COLORADO DIVISION OF RECLAMATION, MINING AND SAFETY MINERALS PROGRAM INSPECTION REPORT

MINE NAME:	MINE/PROSPECTING ID#:	MINERAL:	COUNTY:
Spring Creek Pit	M-1994-097	Sand and gravel	Montrose
INSPECTION TYPE:	INSPECTOR(S):	INSP. DATE:	INSP. TIME:
Monitoring	Dustin M. Czapla	April 17, 2014	14:00
OPERATOR:	OPERATOR REPRESENTATIVE:	TYPE OF OPERATION: 112c - Construction Regular Operation	
Oldcastle SW Group dba United Companies	Tom Davis		
of Mesa County			S - F

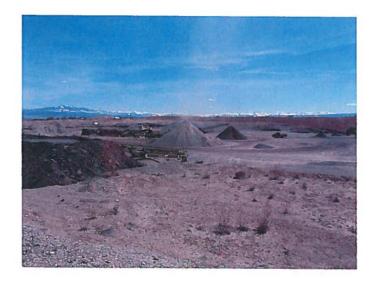
The affected area was marked by fencing and posts that were clearly visible and adequate to delineate the affected area boundary.

The pit has been excavated to a depth of approximately twenty feet. The pit slopes on the east and west sides were approximately 1H:1V. The south slope was graded at approximately 2H:1V and the north slope approximately 3H:1V. Topsoil is stockpiled around the perimeter of the pit. Materials stockpiles are located throughout the pit floor. Wash ponds are located in the south part of the pit. Several piles of waste asphalt were located in the north part of the pit.
